**CITY COUNCIL
MEETING**

AUGUST 6, 2024

CITY COUNCIL MEETING AUGUST 6, 2024 - HANDOUT BY RESIDENT MARK REIDER &
PRESIDENT OF THE BOARD AT TRILOGY AT LA QUINTA
PUBLIC HEARING ITEM NO. 2 - TRAVERTINE PROJECT

TRAVERTINE LA QUINTA CITY COUNCIL MEETING PRESENTATION

La Quinta Village Apartments Versus Avenue 62 Elevated Roadway

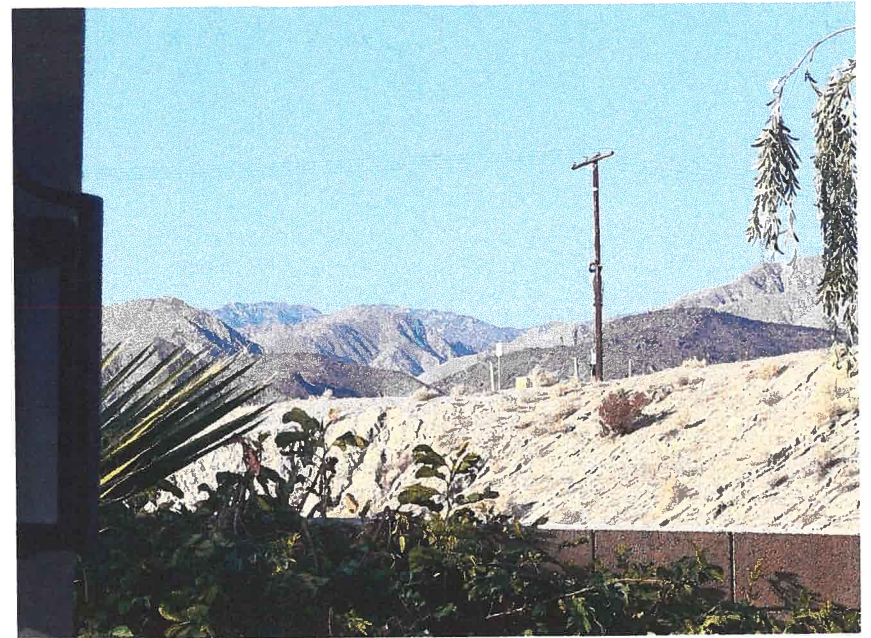
On August 1, 2023 you sent La Quinta Village Apartments back to the Planning Commission – one condition was to drop it to two stories

**Two Story Building is 28 feet 6 inches
Three Story Building is 38 feet 6 inches**

**Roadway height is 36 feet
Top of a vehicle is 42-50 feet**

What should be your direction for this?

- You can't drop the berm from 30 feet to 20 feet
- You can ask for Utilities only to cross Avenue 62
- You can ask for the main entrance to Travertine to be the Jefferson Street Extension

Here are just pictures of cars at night – please picture it coming over the berm

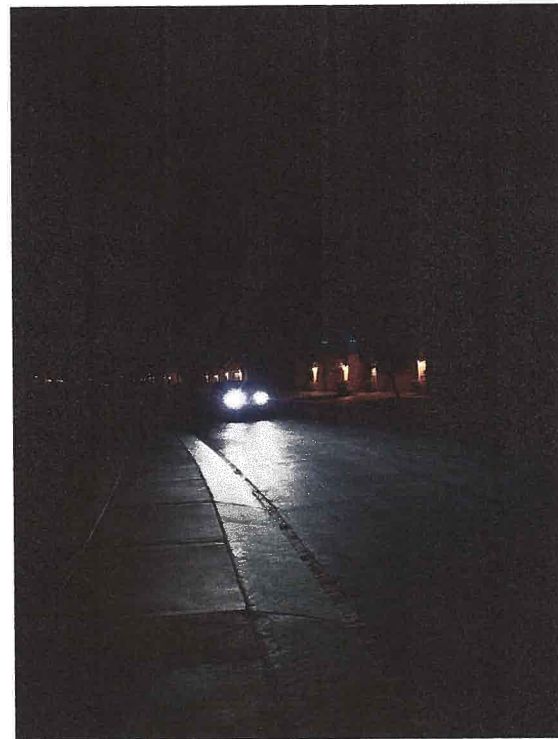
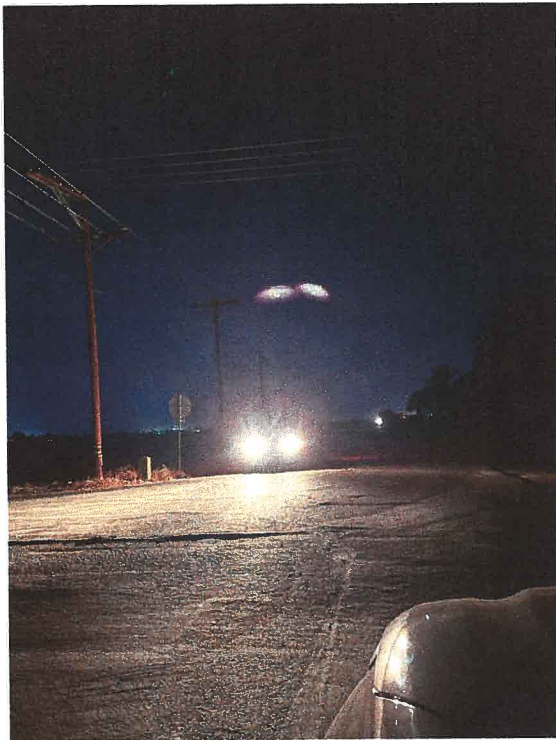
No where does the DEIR address the following items

- Roadway lighting on the elevated roadway
 - With the lights needed to illuminate the elevated roadway, and with the height above the berm, counting the 6 feet for the roadway height, plus 9 to 10 feet for the lights, there is no way that we won't see the lights.
 - They will be 15 feet or more above the existing berm
 - How about headlights? They will be constant, first shining up, level and shining down. And with multiple vehicles every minute, it will be constant

- City Council, please put a Condition of Approval on this project for a Utilities only crossing on Avenue 62
- City Council, please put a Condition of Approval on this project for the Main Travertine entrance to be the Jefferson Extension
